Jodhpur Development Authority, Jodhpur

No : EE-ROB/2020-21/407

Name of Work:- Construction, Supply, Installation, Testing & Commissioning of Civil, Mechanical and Electrical works and Operation & Maintenance of 10 MLD Sewage Treatment Plant by SBR Process on Turnkey Basis at Uchiyarda in Jodhpur, Rajasthan.

The Pre-Bid meeting for the above said work was held as Scheduled in Bid Document on Dated 13.01.2021 at 3:00 PM in the Chamber of Director Engineering, JDA, Jodhpur.

ANNEXURE - 2 KEYPLAN OF PROPOSED STP AT UCHIYARDA (10MLD)

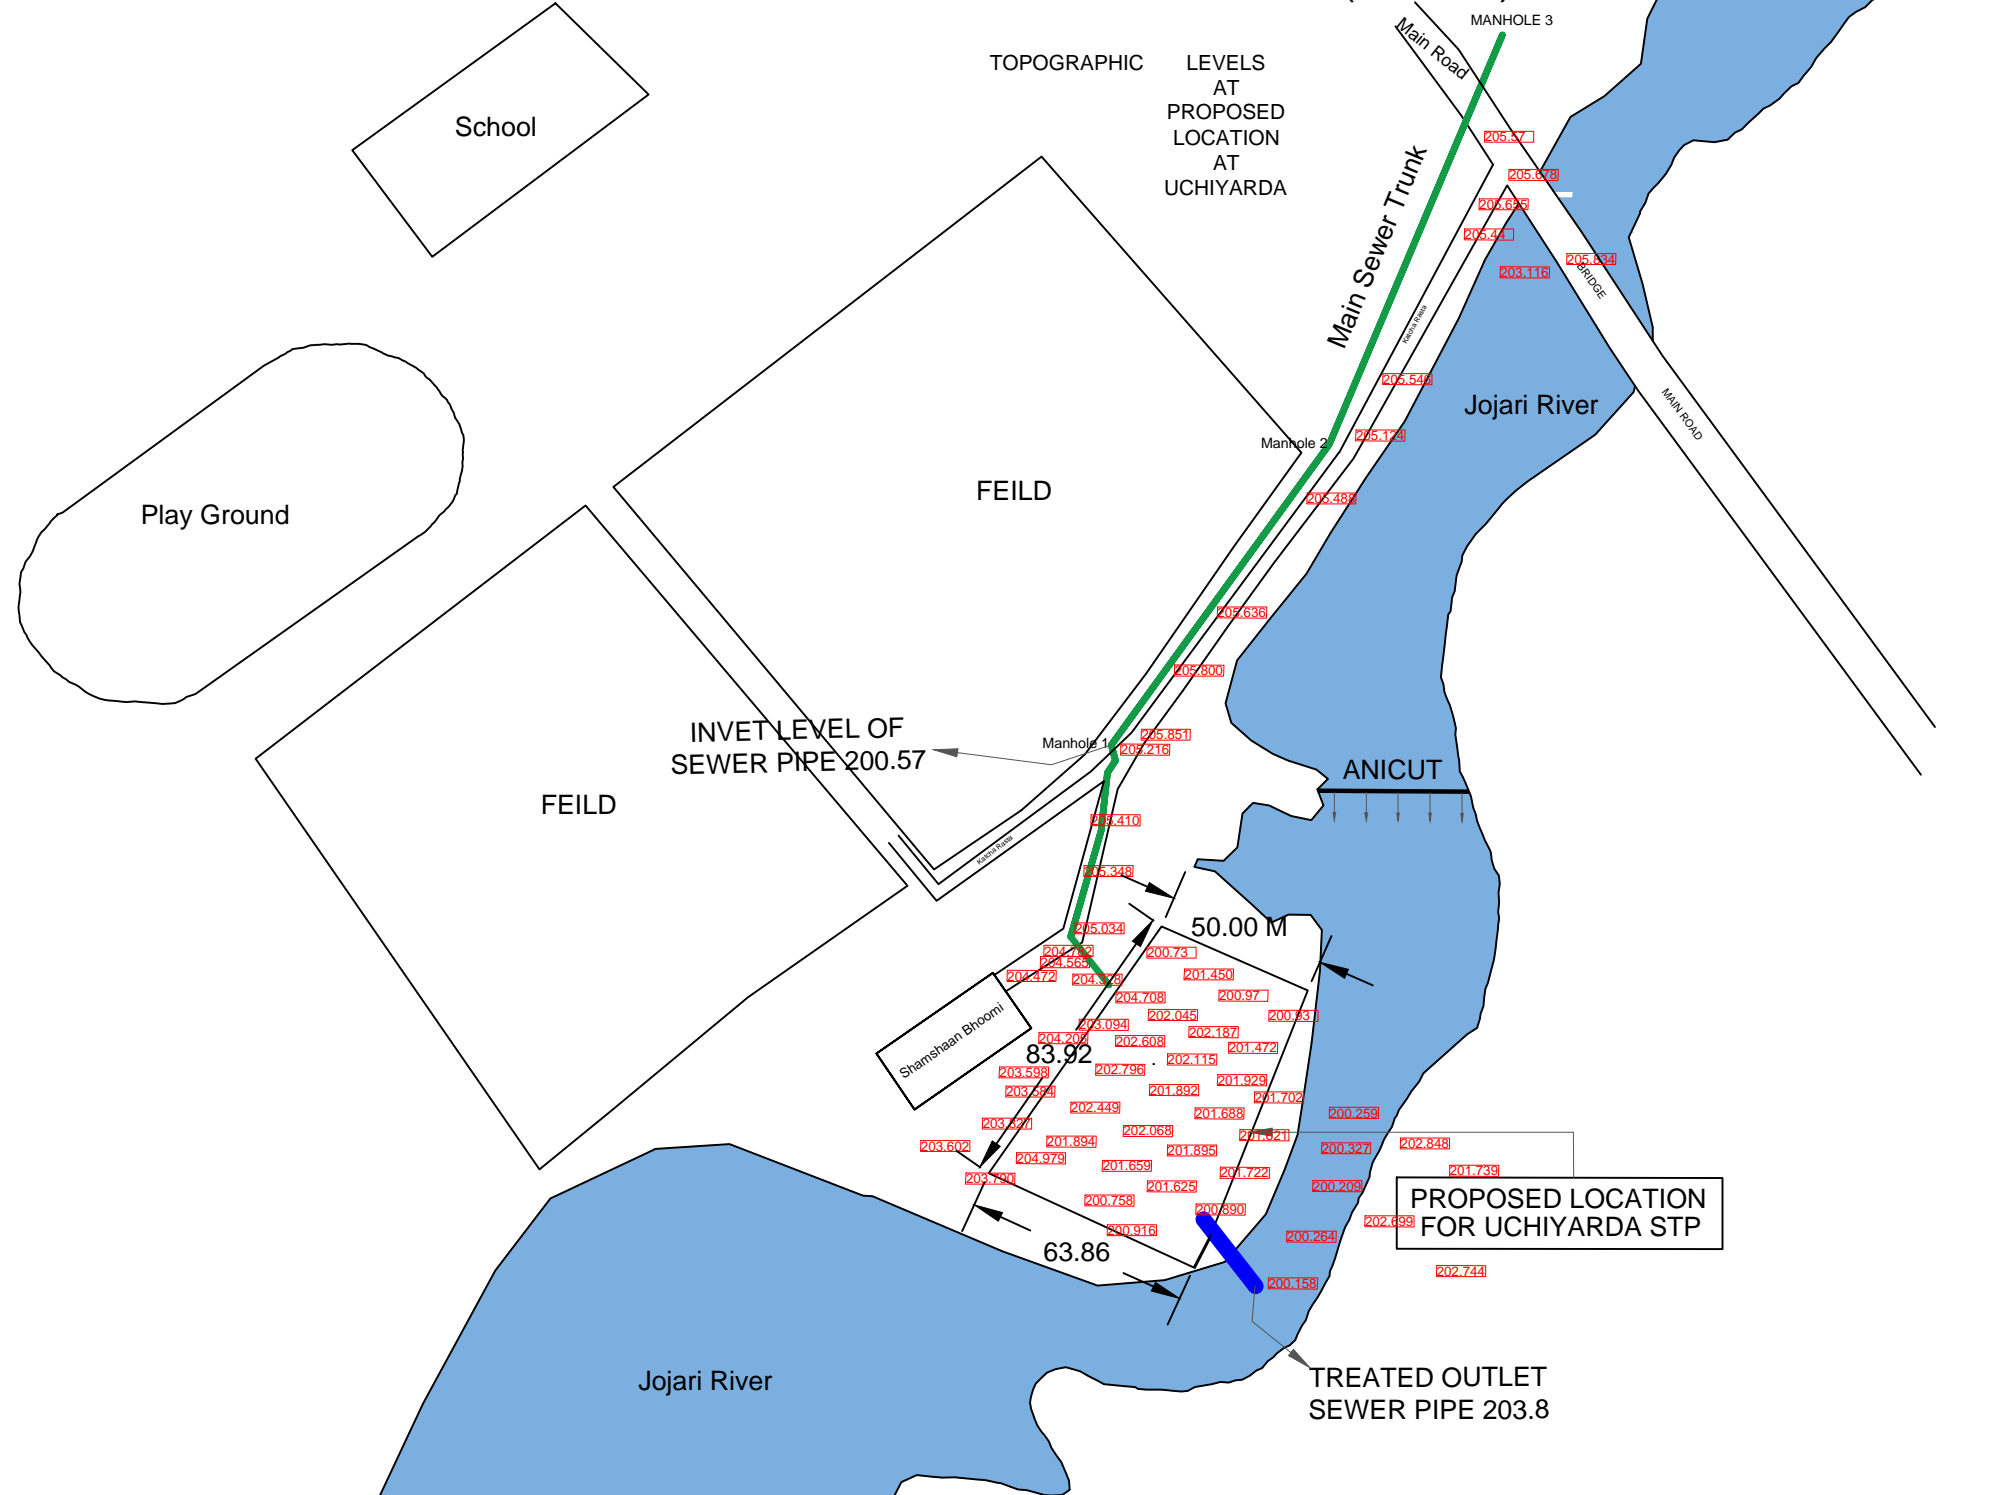
9	Site Plan of proposed STP Part II- Requirements	Levels given on drawing are only towards boundary side of plot. No levels given inside of Plot. Pl. provide contour plan/levels for whole site.	Please refer Annexure-2 for details
10	TPI Agency Charges Section V.PER3	Pl. confirm TPI agency charges, their lodging, boarding charges etc. will be	Section V (1A) PER11 Para (m) and Section V (1A) PER13, 14 Para (kk)

28	FSL of STP Plot Part II- Requirements	Pl. provide HFL of site plot to decide FGL.	Please refer Annexure 2 for details																
29	Peak factor Part II- Requirements	Pl. provide the peak factor or Peak Flow to be considered for design of STP	Peak Factor of 2.25																
30	Raw Sewage quality Section V PER7 clause 2.2: Raw Sewage Quality	Raw sewage quality mentions COD as 1680 mg/l & BOD as 250 mg/l. There seems to be some typing error in COD Values. As per given values BOD/COD ratio is 0.14 & its not treatable biologically. Pl. check & revise COD Value	<table border="1"> <thead> <tr> <th>Design parameter</th> <th>Value for design purpose(STP)</th> </tr> </thead> <tbody> <tr> <td>BOD 5 @ 20o C</td> <td>320 mg/l</td> </tr> <tr> <td>COD</td> <td>650 mg/l</td> </tr> <tr> <td>TSS</td> <td>320 mg/l</td> </tr> <tr> <td>TKN (as N)</td> <td>14.5 mg/l</td> </tr> <tr> <td>TP</td> <td>5.2 mg/l</td> </tr> <tr> <td>PH</td> <td>6-9</td> </tr> <tr> <td>Flow</td> <td>As per capacity mentioned above Average Flow</td> </tr> </tbody> </table> <p>Report attached. Refer Annexure-1</p>	Design parameter	Value for design purpose(STP)	BOD 5 @ 20o C	320 mg/l	COD	650 mg/l	TSS	320 mg/l	TKN (as N)	14.5 mg/l	TP	5.2 mg/l	PH	6-9	Flow	As per capacity mentioned above Average Flow

ITEM	LEVEL
INVERT LEVEL OF SEWER MAIN LINE	200.57
AVERAGE NGL OF PROPOSED STP LAND	201.96
EXISTING NEAR BY ROAD BRIDGE LEVEL (APPROX. 350 M FROM PROPOSED STP PLANT)	205.83
EXISTING BED LEVEL OF JOJARI RIVER	200.33
INLET LEVEL OF TREATED WATER INTO JOJARI RIVER	203.80
HFL OF JOJARI RIVER CHANNEL	205.80
HFL OF STP PLANT	205.83
FINISH GROUND LEVEL OR PLINTH LEVEL OF STP PLANT	206.83

**ANNEXURE -04
KEYPLAN OF PROPOSED STP AT VIVEK VIHAR**

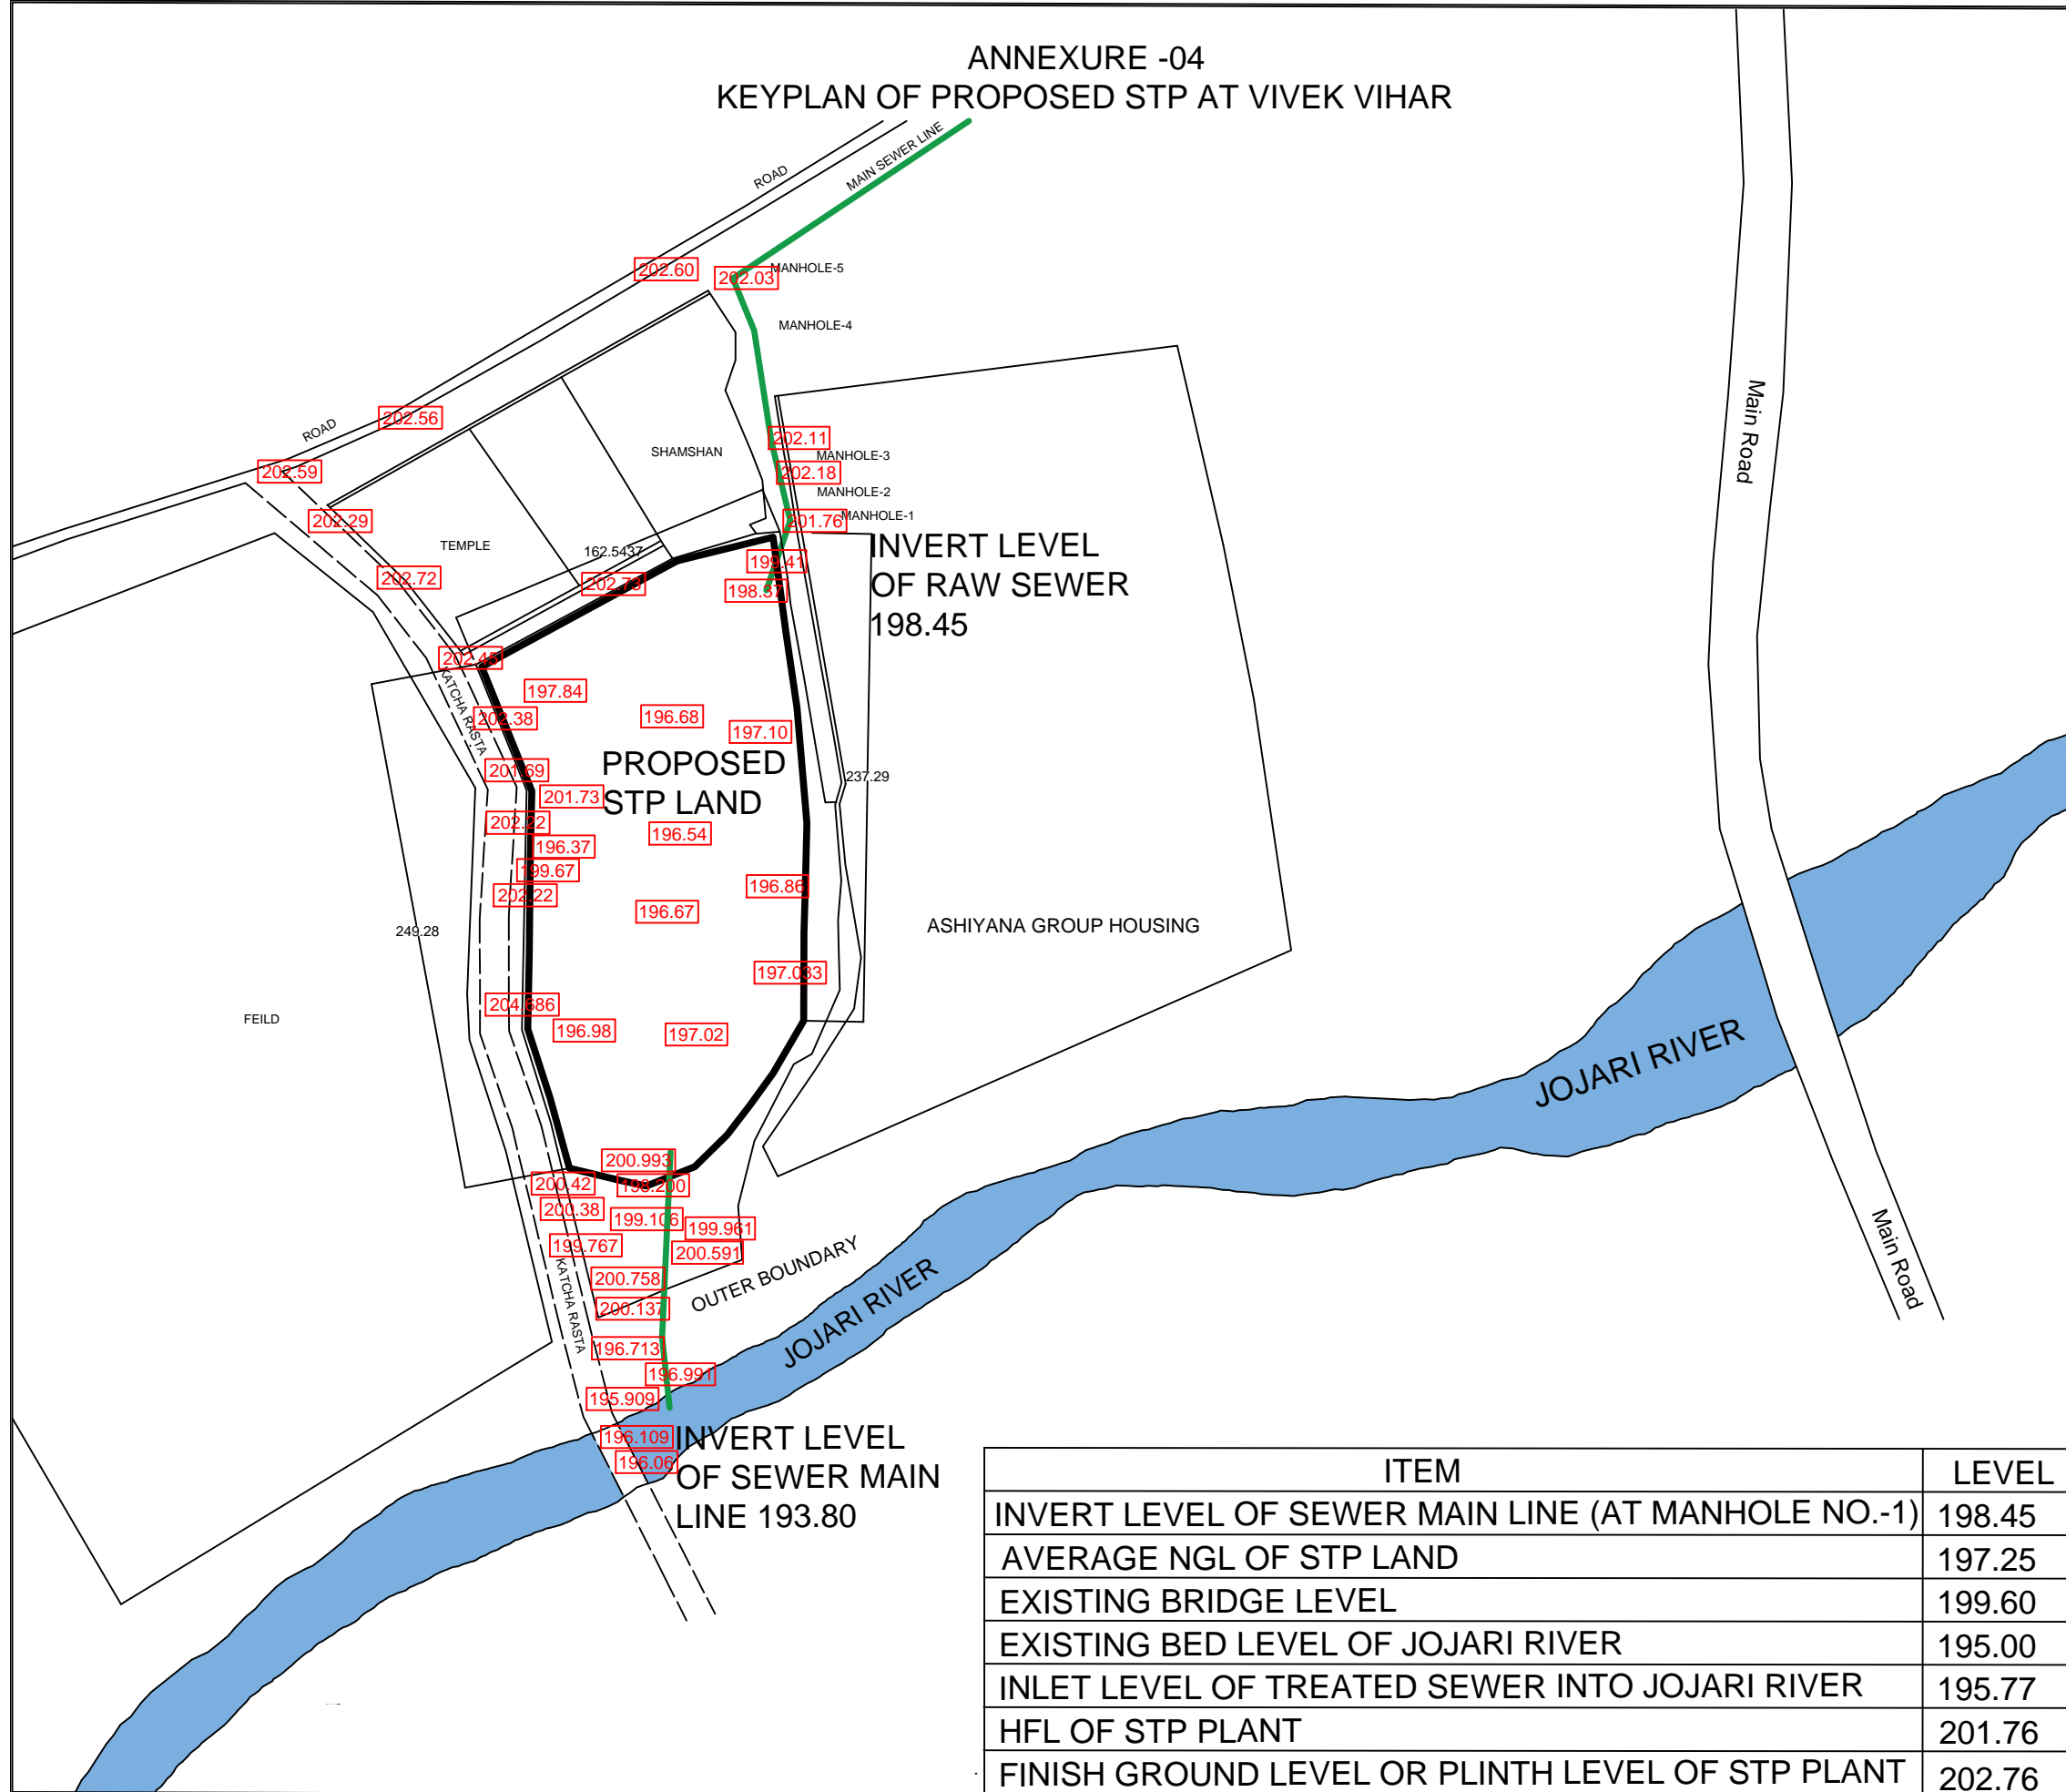
26	Invert level of Raw sewer line Part II- Requirements	Pl. provide Invert level of Raw sewer line as values mentioned on site plan are blurred & not clear	Please refer Annexure-4 for details.																
27	FSL of Drain Part II- Requirements	Pl. provide FSL of disposal body (jojari river) as values mentioned on site plan are blurred & not clear & its required for design of plant hydraulics to dispose the treated sewage thru gravity.	Please refer Annexure-4 for details																
28	FSL of STP Plot Part II- Requirements	Pl. provide HFL of site plot to decide FGL.	Please refer Annexure-4 for details																
29	Peak factor Part II- Requirements	Pl. provide the peak factor or Peak Flow to be considered for design of STP	Peak Factor of 2.25																
30	Raw Sewage quality Section V PER7 clause 2.2: Raw Sewage Quality	Raw sewage quality mentions COD as 1680 mg/l & BOD as 250 mg/l. There seems to be some typing error in COD Values. As per given values BOD/COD ratio is 0.14 & its not treatable biologically. Pl. check & revise COD Value	<table border="1"> <thead> <tr> <th>Design parameter</th> <th>Value for design purpose(STP)</th> </tr> </thead> <tbody> <tr> <td>BOD 5 @ 20o C</td> <td>340 mg/l</td> </tr> <tr> <td>COD</td> <td>620 mg/l</td> </tr> <tr> <td>TSS</td> <td>350 mg/l</td> </tr> <tr> <td>TKN (as N)</td> <td>15.3 mg/l</td> </tr> <tr> <td>TP</td> <td>4.9 mg/l</td> </tr> <tr> <td>PH</td> <td>6-9</td> </tr> <tr> <td>Flow</td> <td>As per capacity mentioned above Average Flow</td> </tr> </tbody> </table> <p>Report attached. Refer Annexure-3</p>	Design parameter	Value for design purpose(STP)	BOD 5 @ 20o C	340 mg/l	COD	620 mg/l	TSS	350 mg/l	TKN (as N)	15.3 mg/l	TP	4.9 mg/l	PH	6-9	Flow	As per capacity mentioned above Average Flow

ANNEXURE- 6 TYPICAL C.C ROAD DETAIL

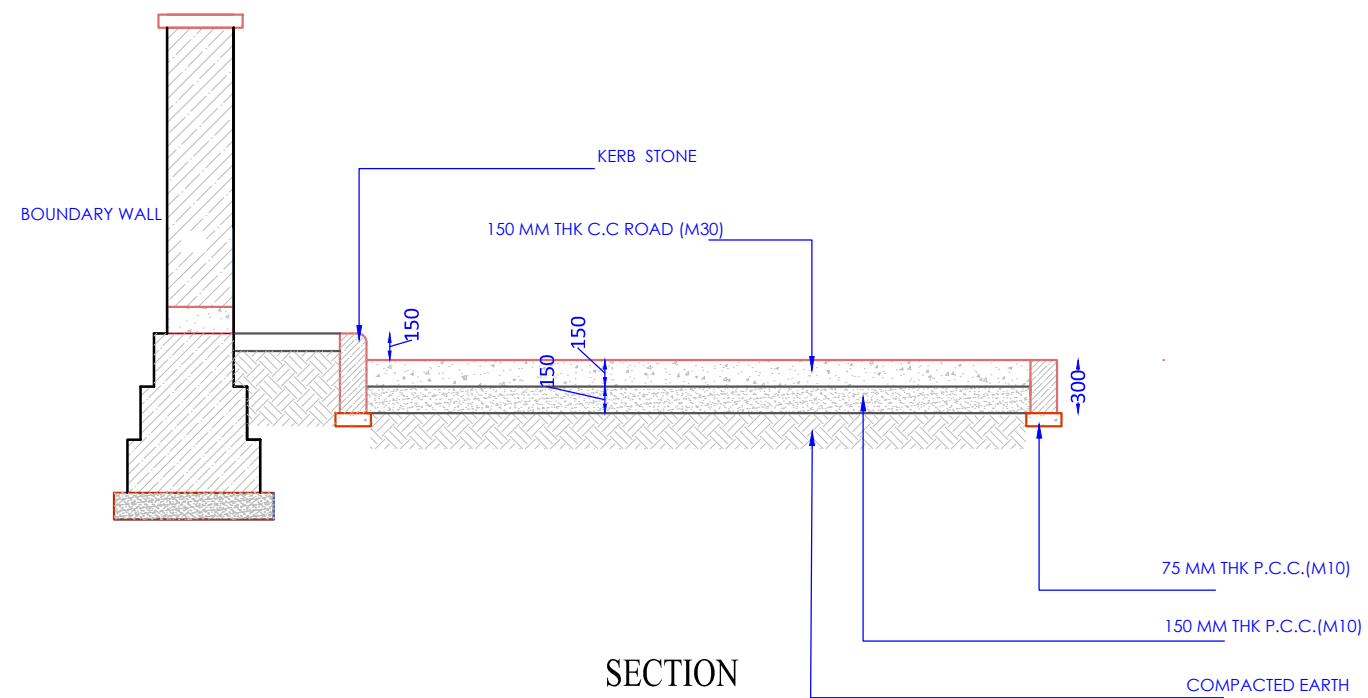
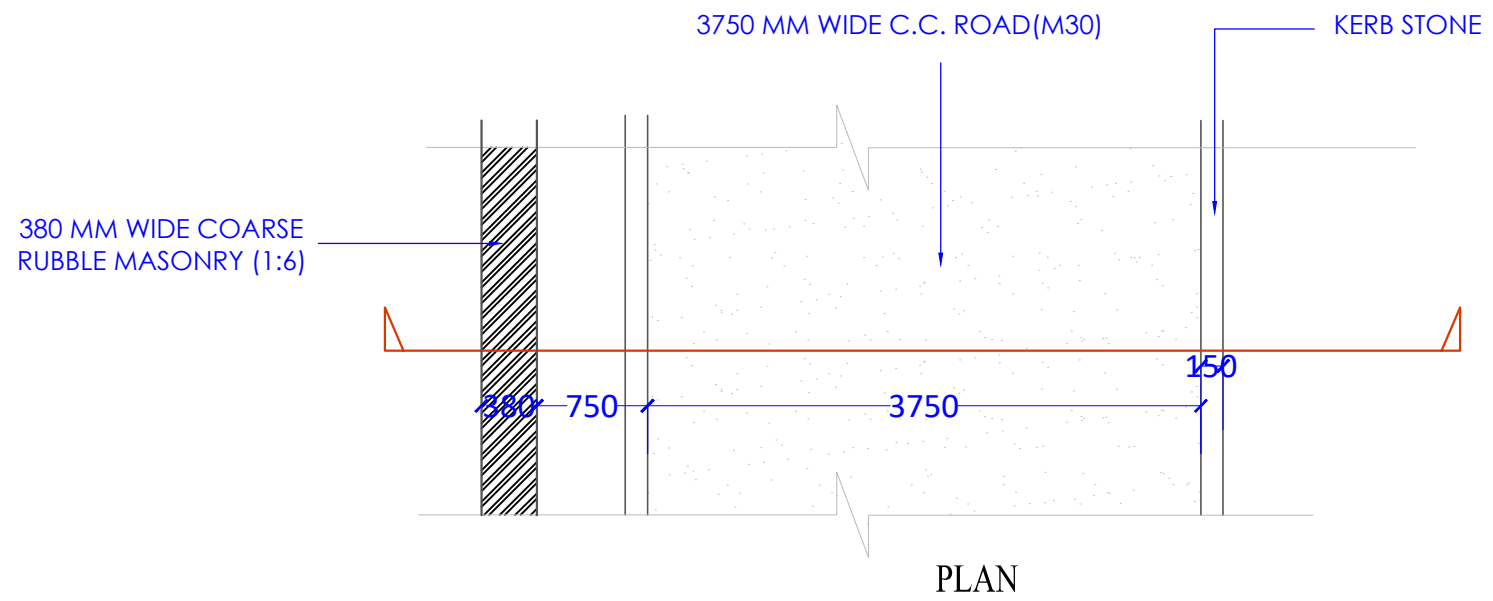
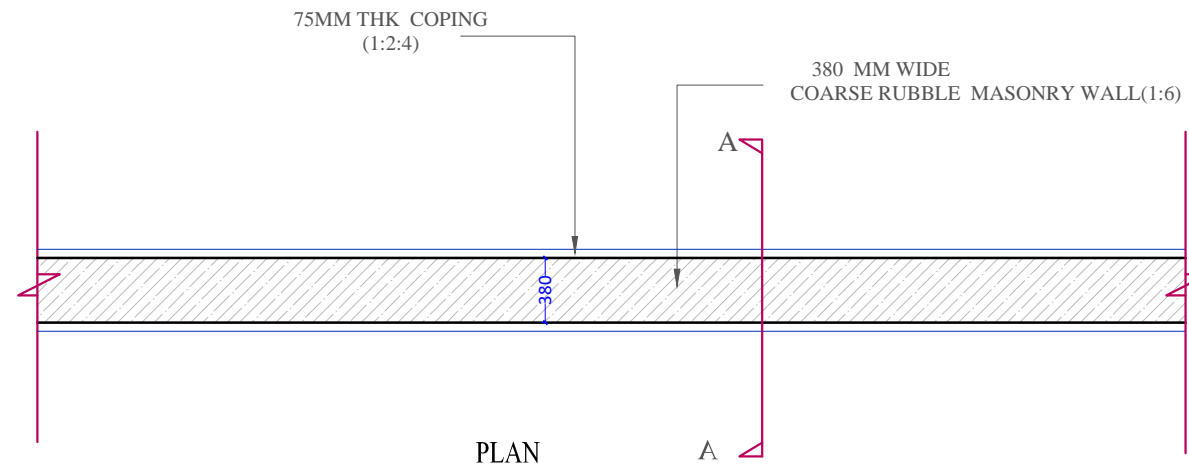
10	General	Kindly provide the road section, its width, layout & its material of construction.	Please find attached Annexure 6 for road cross section details. Road network as per Bidders design and as approved by EIC so that all the units of the STP plant are accessible/ connected by roads.
11	General	Kindly provide the coating specification On the inside face of RCC in contact with liquid for tanks.	As per CPHEEO manual and as per bidders design, drawing and as approved by EIC.
12	General	Kindly provide the coating/painting specification 1. On the outer side in contact with soil. On the outer side in contact with sunlight.	As per CPHEEO manual and as per bidders design, drawing and as approved by EIC.
